Enclosure 2

**Draft Response to RAI NP-2.4-x with SAR
Markups**

Figure 2-1
Waste Control Specialists Facility Site Plan

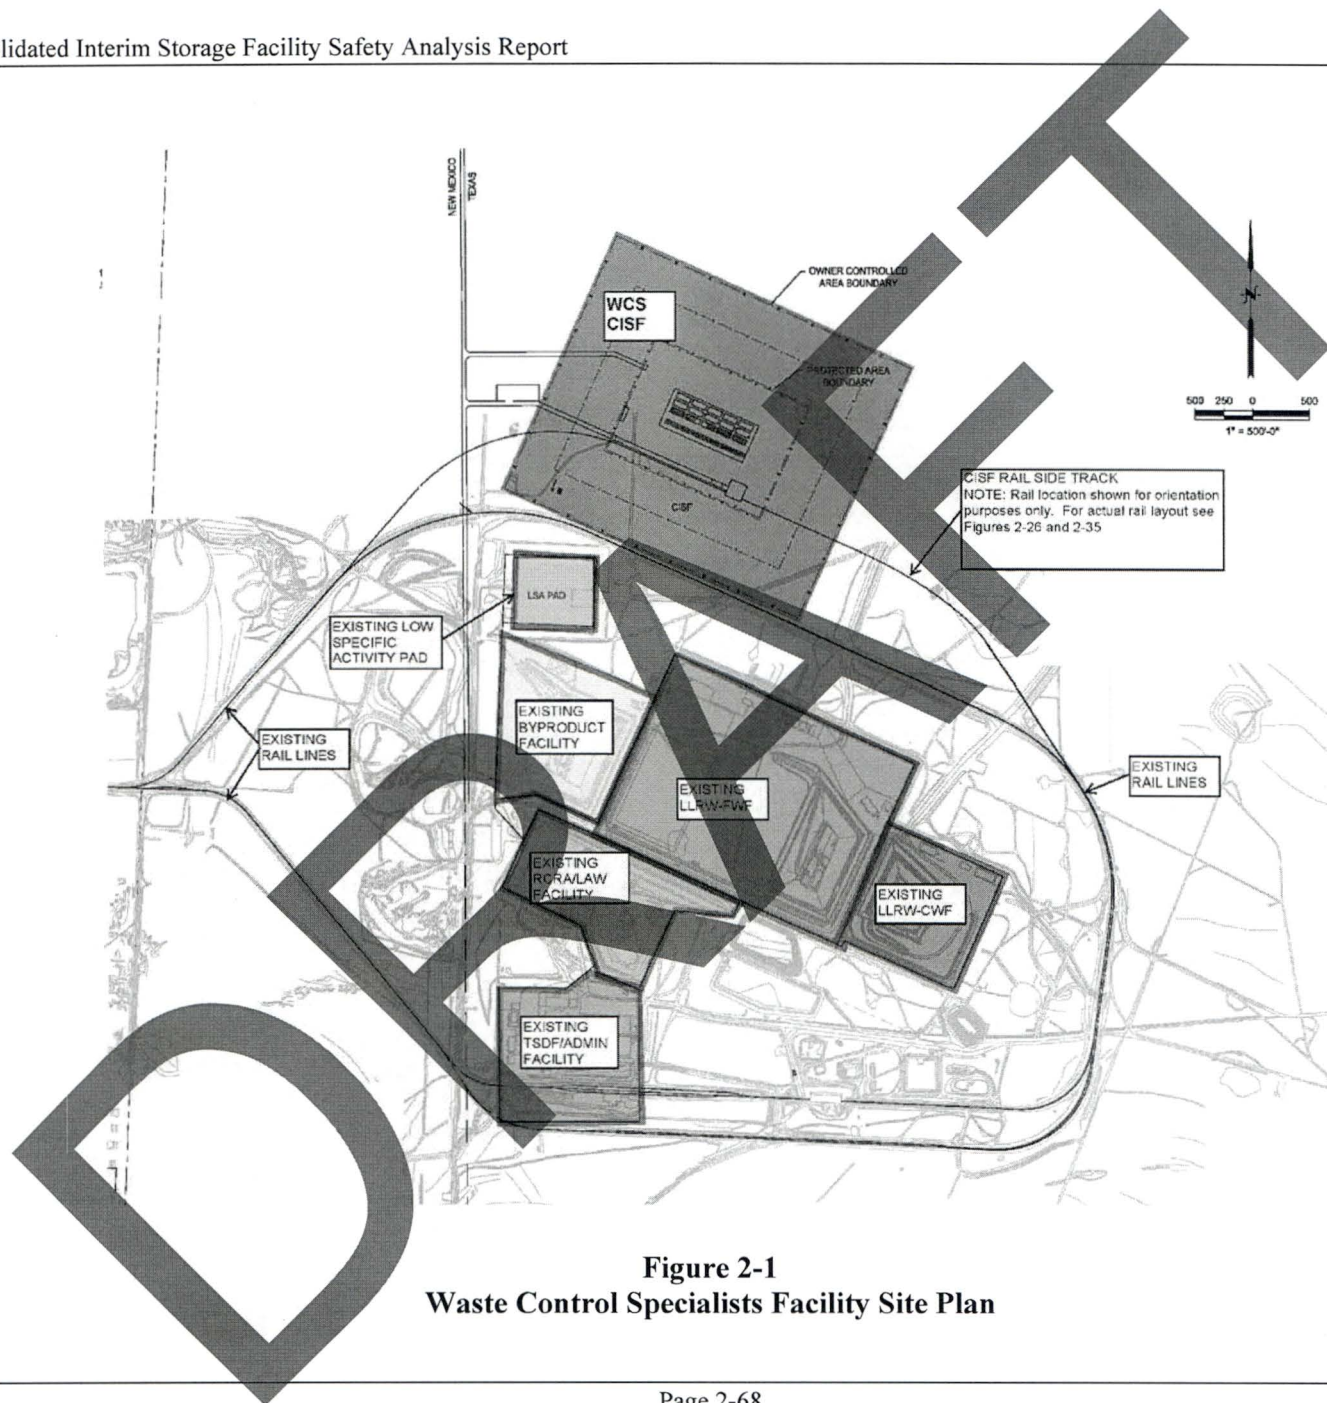
Provide clarification as to what is the exact design of WCS CISF rail side track, in particular the section east of the storage area.

In reviewing the SAR, the NRC determined that the eastern portion of the CISF rail side track are not consistently identified in the site plan depicted in SAR Figures 2-1, 2-3, 2-4 and 2-15 versus that depicted in SAR Figure 2-35 and SAR Chapter 2, Attachment B, Figures 1.1.2-2 and 2.2.1-1. The drainage area P DA 3 depicted in the former group of figures appears to be larger than that depicted in the latter. Difference in the area of drainage P DA 3 may cause different flood water level on the south eastern corner of the storage area. If drainage area P DA 3 is correctly depicted in SAR Figure 2-35, the NRC staff requests that ISP correct the side rail track design in SAR Figures 2-1, 2-3, 2-4 and 2-15. If drainage area P DA 3 is correctly depicted in SAR Figure 2-1, the NRC request that ISP provide a floodplain analysis using the site plan in Figure 2-1.

The actual WCS CISF rail side track layout is shown in SAR Figures 2-26 and 2-35, which are in agreement with the floodplain analysis. SAR Figures 2-1, 2-3, 2-4, and 2-15 show the rail for orientation purposes only. To clarify this, SAR Figures 2-1, 2-4, and 2-15 have been updated with a note that indicates that the rail side track is shown for orientation purposes only and that the actual rail layout is shown on SAR Figures 2-26 and 2-35. SAR Figures 2-26 and 2-35 both show the relationship between the location of the rail line and the drainage playa for drainage area P DA 3. SAR Figure 2-3 has been updated in response to RAI NP 2.2-2 and no longer shows the rail side track.

SAR Figures 2-1, 2-4, and 2-15 have been revised as described in the response.
